KUAMUT RAINFOREST CONSERVATION PROJECT

Project Title	Kuamut Rainforest Conservation Project
Version	1.2
Project Location	Malaysia, Sabah
Report ID	VCS.VAL.21.74

Report Title	CCB & VCS Validation Report for “Kuamut Rainforest Conservation Project”
Client	Permian Malaysia Sdn. Bhd
Pages	123
Date of Issue	11-March-2023
Prepared By	Earthood Services Pvt. Ltd.
Contact	409-410, Tower B4, Spaze I-Tech Park, Sohna Rd, Sector 49, Gurugram, Haryana 122018 Telephone: +91 124 420 4599 Email: info@earthood.in Website: www.earthood.in
Approved By	Dr. Kaviraj Singh
Work Carried Out By	Team Leader: Shreya Garg Technical Expert (14.1) & Methodological Expert: Michael O’Brien Technical Reviewer: Kaviraj Singh Technical Expert (14.1) to TR: Zainab Hassan Trainee (Validator): Riya Sharma Trainee (Validator): Vishnu Panicker

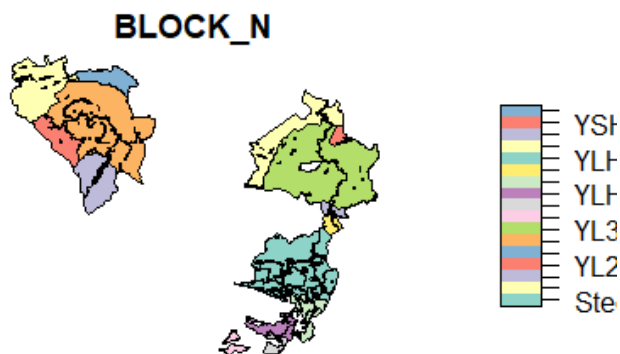
The slope analysis file read the project boundaries shapefiles to carry out cluster analysis to contiguous 'flat areas' and 'steep areas'

The analysis showed that flat contiguous areas identified suitable for mosaic. Cluster flat area came out 53,637 ha and mosaic coupes area came out as 46664.18 ha. The R calculation file returned the shapefiles of IFM coupes, Mosaic coupes, Mosaic plant, Mosaic unplanted and No-Go areas.

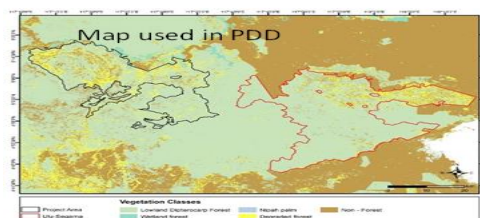
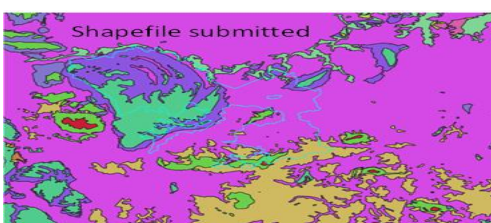
1. Based on the stratification, the project area is divided into four strata as mentioned in table 15 and shown in figure 26 in the PDD. The area in shapefiles submitted in Folder 5 is not matching the area mentioned in table 15 of the PD.					
Strata	Area (ha) as per PDD	Area (ha) as per GIS files	Difference	Proportion Of Project Area	
Stratum 1 (Inoperable)	4671	4753.2	-82.2	0.056	
Stratum 2 (Natural Forest Management)	34654	38163.9	-3509.9	0.4156

Stratum 3 (selective logging within Mosaic Planting)	6866	6992.5	-126.5	0.0823
Stratum 4 (planting areas within Mosaic Planting)	37190	37849.2	-659.2	0.446
Total	83381	87758.9	-4377.9

Request PP to provide shapefile based on the stratification as per report or else provide proper justification on why there is mismatch in the strata areas.

- The vegetation classification for the project area and reference area cannot be verified as the vegetation class mentioned in the PDD figure 21 at page 89 is different in comparison to vegetation classes in shapefile submitted data referred from folder 34 state-wide vegetation. Request to submit the vegetation layer same that has been used for PDD development, so that a comparative analysis can be done.

- The reference area mentioned for the Natural Forest Management in the report does not match with the submitted shapefile. Based on the shapefile the area calculate is 1272.68 Km², whereas in the report it mentioned the reference area under NFM is 2040 km² approximately.
- For figure 24 and 25 PP is requested to provide the spatial datasets generated using the slope cluster analysis. And, please guide the exact folder and sub-folder for finding data for figures 33 and 34.
- PP is requested to submit the copy of Carnegie Airborne Observatory (CAO 2012) Protocol followed for field inventory to validate the SOP submitted.

Project participant response	Date : 16/05/2022
This is described on page 74 of the PD under section '3.1.3, Project Boundary' "A map of the project boundary is provided above in .figure 1 It must be noted that the size of the project area in the official shapefile is slightly larger than the area gazetted as the Class I forest reserve (shapefile area is 84,800 ha while the gazetted area is 83,381 ha). When the shapefile has been used in the calculations, the areas have been adjusted so the project area in the calculations matches the gazetted area."

3. This is a mistake in the PD, the correct area is indeed 1272 km². The PD has been modified with the correct number.
4. All the shapefiles are in the folder '05. KML files and project zone maps'. The output of the 'cluster analysis' are used to visually guide the coupe selection and are now provided in subfolder 'ClusterAnalysisFlatOutline' with the shapefiles named as 'TwoFlatAreas1haRes'. Figure 33 is of the NFM harvesting grid showing the years of harvest under the baseline. The spatial files are provided both as KMZ and shapefiles 'IFMCoupes_THP_Grid' in the subfolder 'IFMCoupes'. Figure 34 is likewise the grid showing the annual operating areas for Mosaic Planting Approach area, we provide them separately for each strata with the shapefiles 'MosaicPLANT_THP_Grid' for the 'planted' strata in the subfolder 'MosaicPLANT' and the unplanted strata shapefiles in the 'MosaicUNplanted' subfolder with the 'MosaicUNplanted_THP_Grid' filenames.
